Service Information Bulletin

SUBJECT	DATE
Diagnostics	July 2017

Publication Number / Title	Platform	Section Title	Change
DDC-SVC-MAN-0140	DT12 Transmission	SPN 521733/FMI 3	Updates to existing procedures.
		SPN 521733/FMI 4	
		SPN 521733/FMI 5

45801

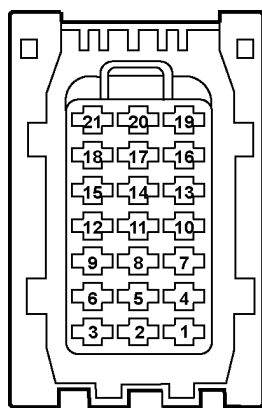
4. Measure the voltage between pins 1, 2, 3, 4, and 6 of the TCM X1 21-pin connector (ignition/battery voltage) and ground. Is voltage less than 11.5 volts?
 - a. Yes; restore voltage to pins 1, 2, 3, 4, and 6 of the TCM X1 21-pin connector.
 - b. No; Go to step 5.
5. Turn the ignition OFF.
6. Measure the resistance between pins 16, 19, 20, and 21 of the TCM X1 21-pin connector and the negative battery post. Is resistance greater than three ohms?
 - a. Yes; restore battery ground to pins 16, 19, 20 and 21 of the TCM X1 21-pin connector.
 - b. No; Go to step 7.
7. Are any AMT Solenoid faults (SPNs 521736 through 521752 FMI any) also present (active or inactive)?
 - a. Yes; replace the TCM and the Automated Manual Transmission (AMT) shift control unit. Clear faults after repair.
 - b. No; replace the TCM. Clear faults after repair.
